TO: T10 Membership
FROM: Paul A. Suhler, Quantum Corporation
DATE: 12 September 2006
SUBJECT: T10/05-049r5, SSC-3 Physical Device Model

Figure X – UML description of physical device

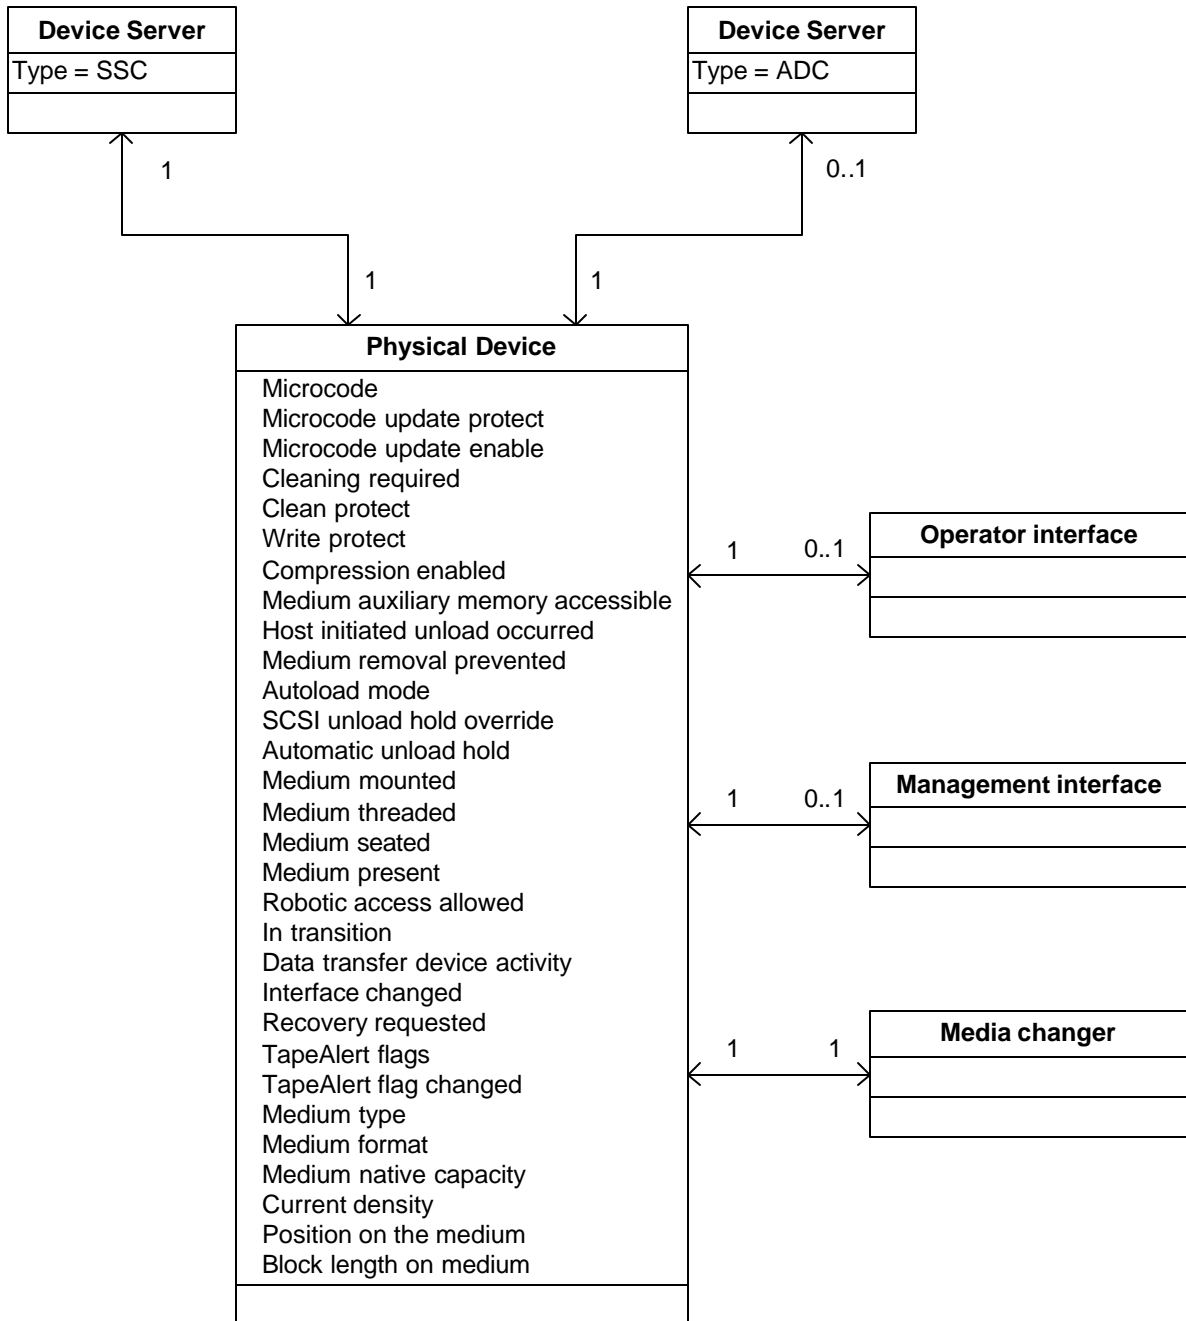
These entities perform operations that change various attributes of the physical device. These attributes affect the operations on a volume. Figure X shows in UML notation an example of the entities in a SCSI target device, and shows the attributes which comprise the physical device.
